ADDENDUM #1 - 6/16/2025
REVISED SHEETS: D-1, D-2, D-7, INT-2, INT-3, P-1, P-2, P-4, U-1, U-2, U-3, U-5, U-6, U-12, U-13, U-14, U-15, W-1, W-2, W-5, W-7, E-1, E-2, E-4, E-7, AND E-8.
REVISION #1 - 8/28/2025
REVISED SHEETS: D-6, INT-2, INT-3, INT-4, INT-6, INT-7, ALL P SHEETS, U-1 TO U-6, U SCHEDULES, W-1 TO W-7, ALL E SHEETS, ADDED PM-13A, AND ALL X SHEETS.

E. MAIN STREET & S. HANCOCK STREET
ASSESSMENT DISTRICT - 2025

CITY PROJECT NO. 15125
CONTRACT NO. 8784

X-13

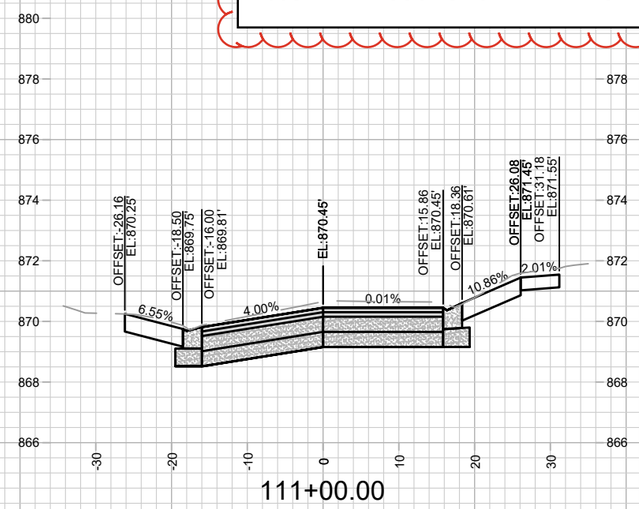
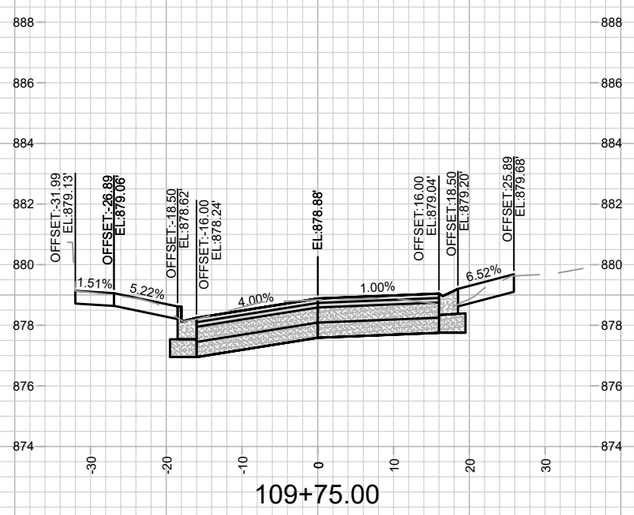
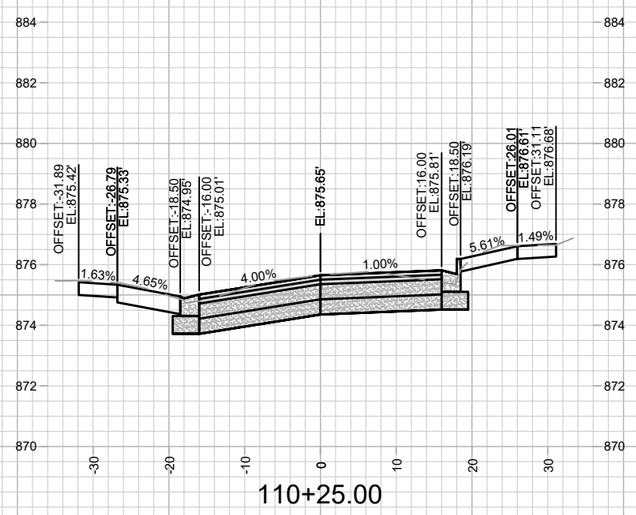
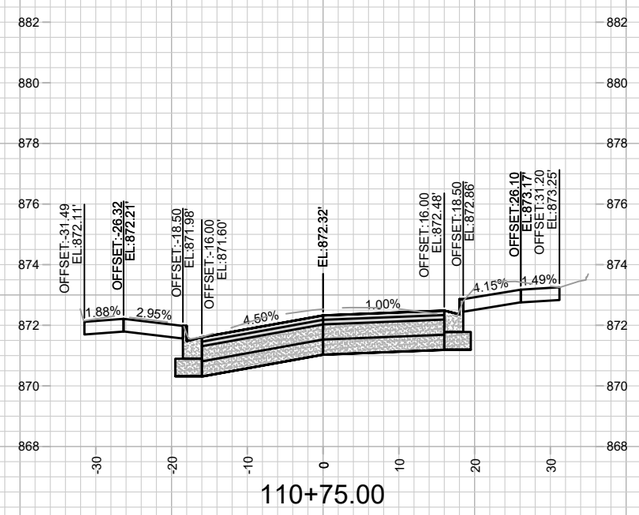
REVISION #1 - 8/28/2025
ADJUSTED HANCOCK ST CENTERLINE GRADES.
